APPENDIX B
POST-DR II DESIGN CHANGES

Oregon Square
November 5, 2015

CAMPUS COMMENTS TO ADDRESS - POST DR II

ENTRY GATES : LIGHTS GATE (WEST)

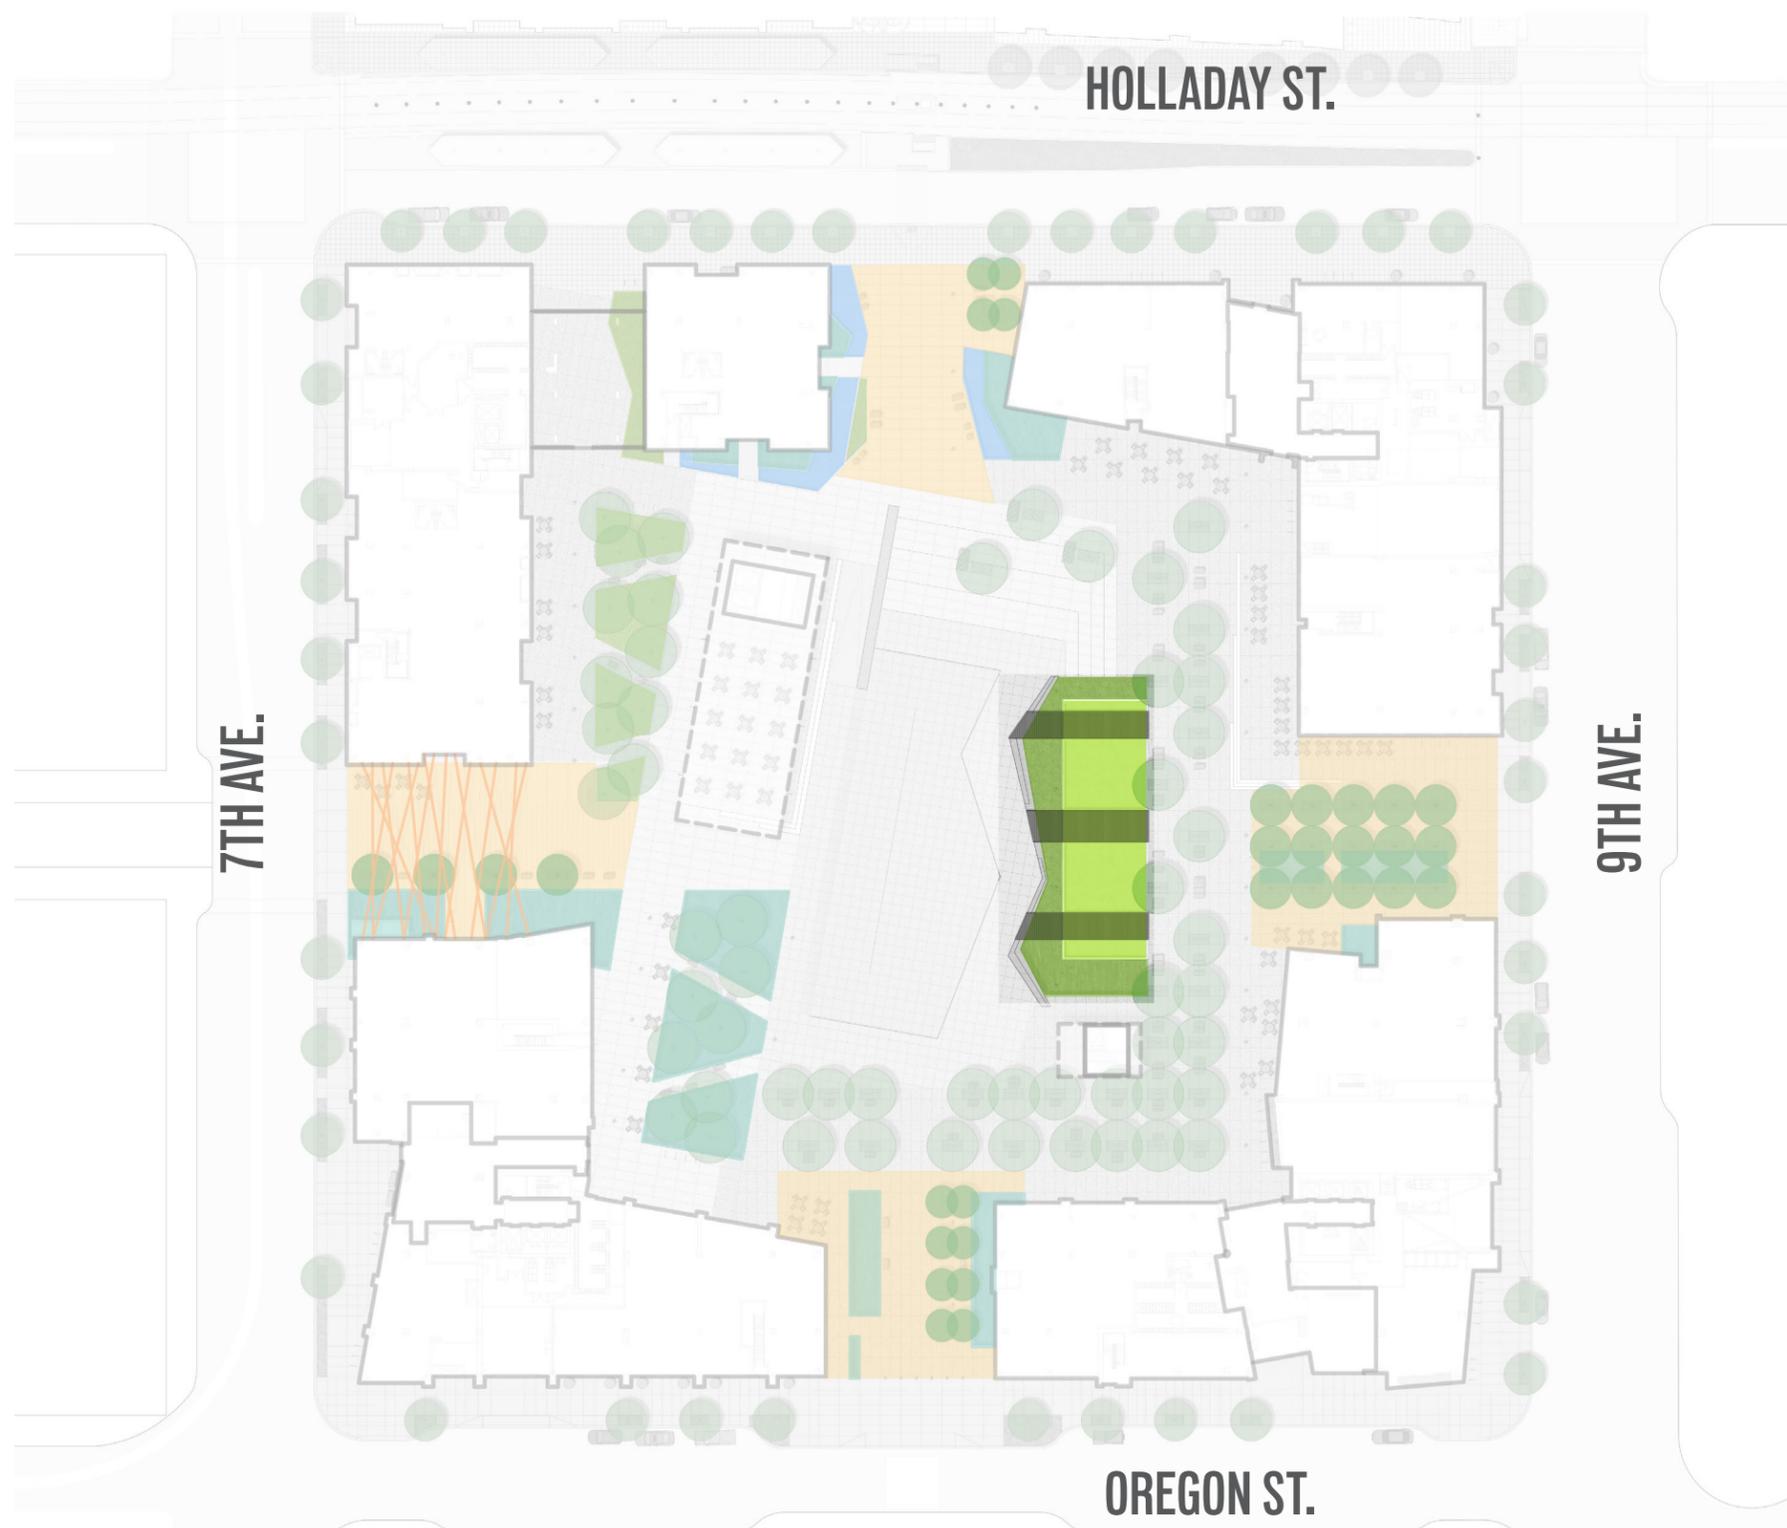
The Lights Gate retains a sense of amplitude to acknowledge the connection of the square west towards the Convention Center.

By removing the storm water planter on the North side of the gate, the edges and corners of the building maintain a better connection to the pedestrian space and flow of visitors.

The emphasis on the overhead lights will create a festive sense of announcement and arrival to the square.

MOBILE SEATING - OREGON SQUARE

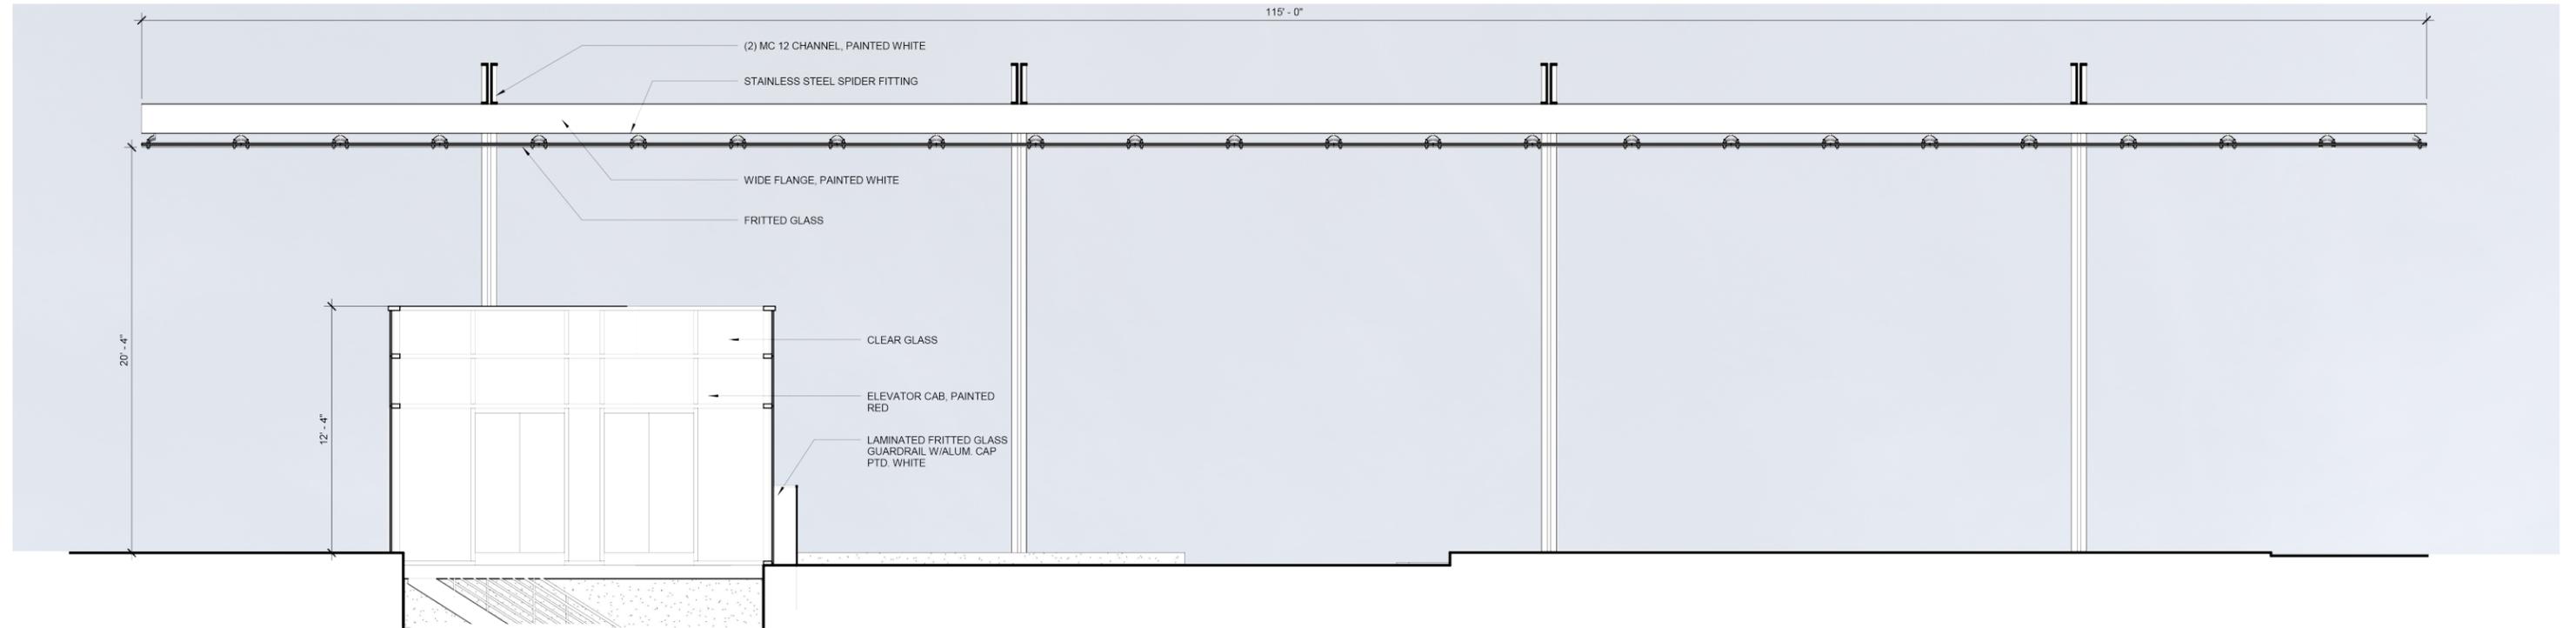
MOBILE SEATING:

Retail will be encouraged to provide cafe seating, and the owner will include a stock of mobile seating that they will use as needed, but we find it difficult to condition approval on this.

MAIN PAVILION - W/O RETAIL

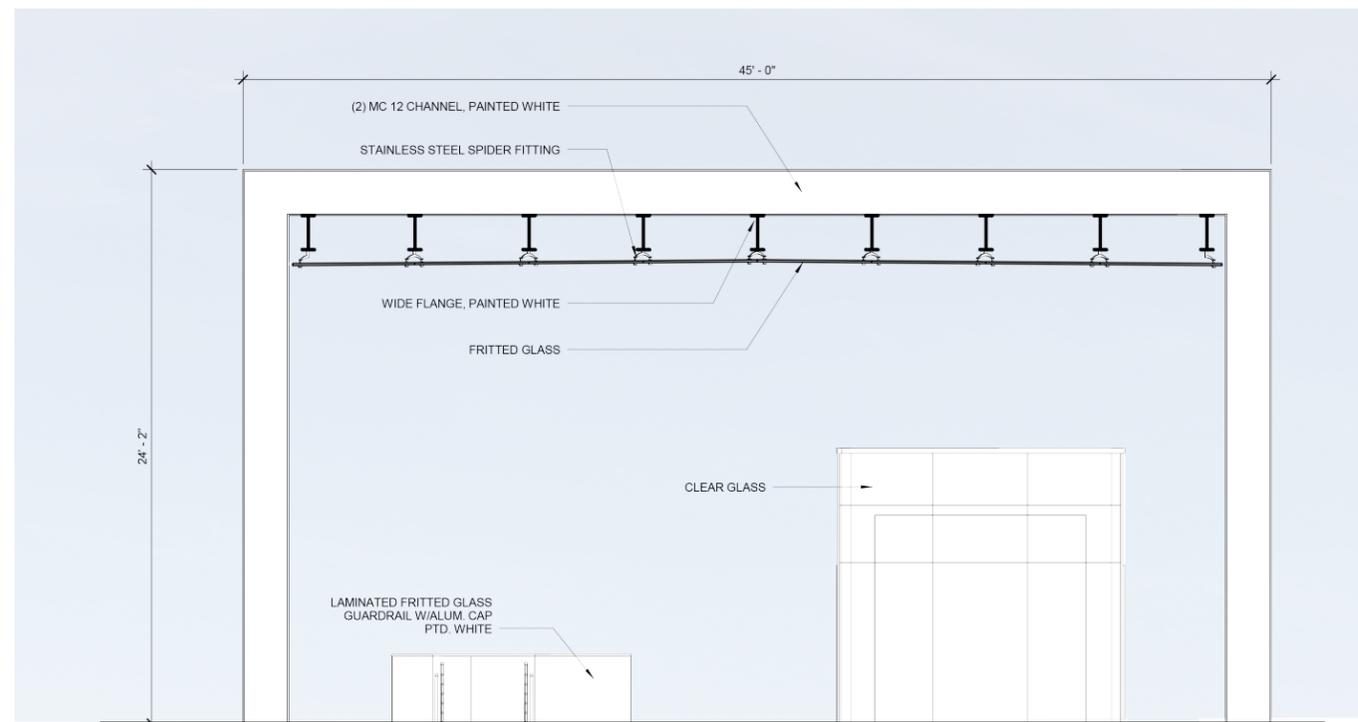
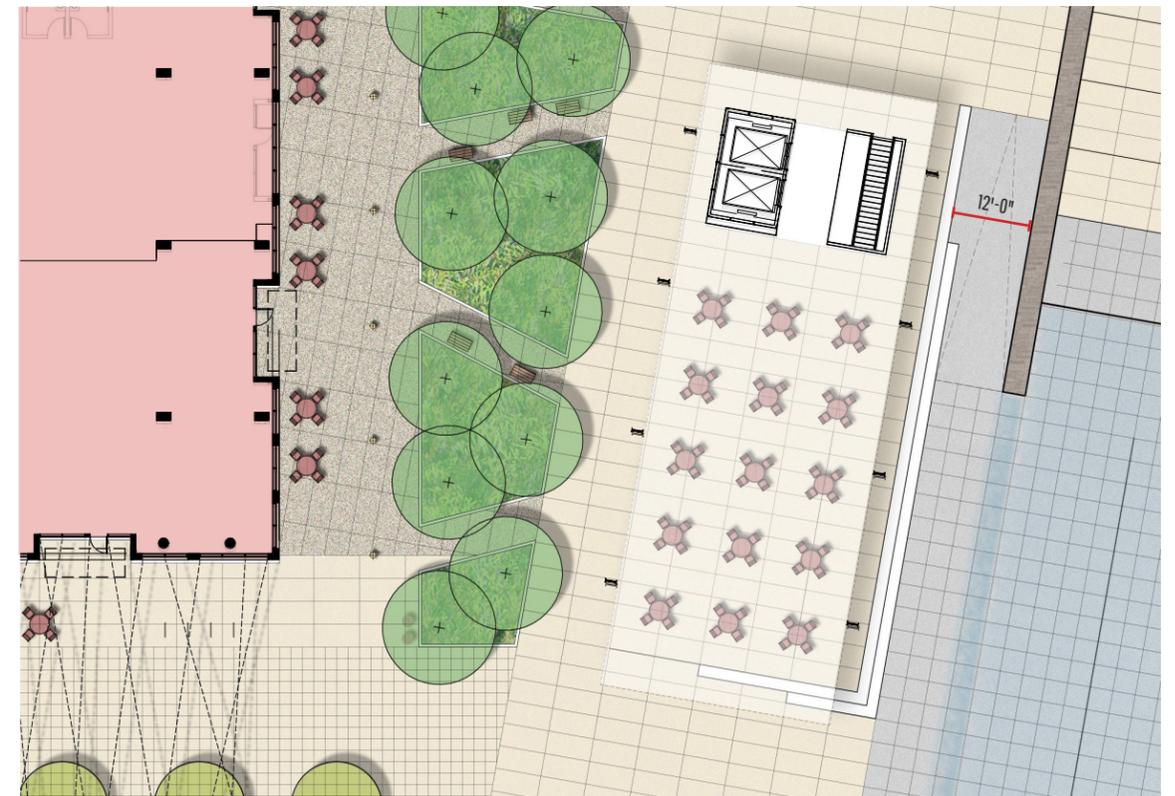
Rotate the elevators in the northwest pavilion so they face west to reduce their presence in the park and open up view and access from the north gate. Would also give more space west of the chevron bench, which may not be the right shape for the space or flow of movement. Small retail (even micro) should be more linear and in line with the shifted elevator at west edge of canopy.

Elevators will be staged on the P-1 level, and will only be visible on the plaza level when called.
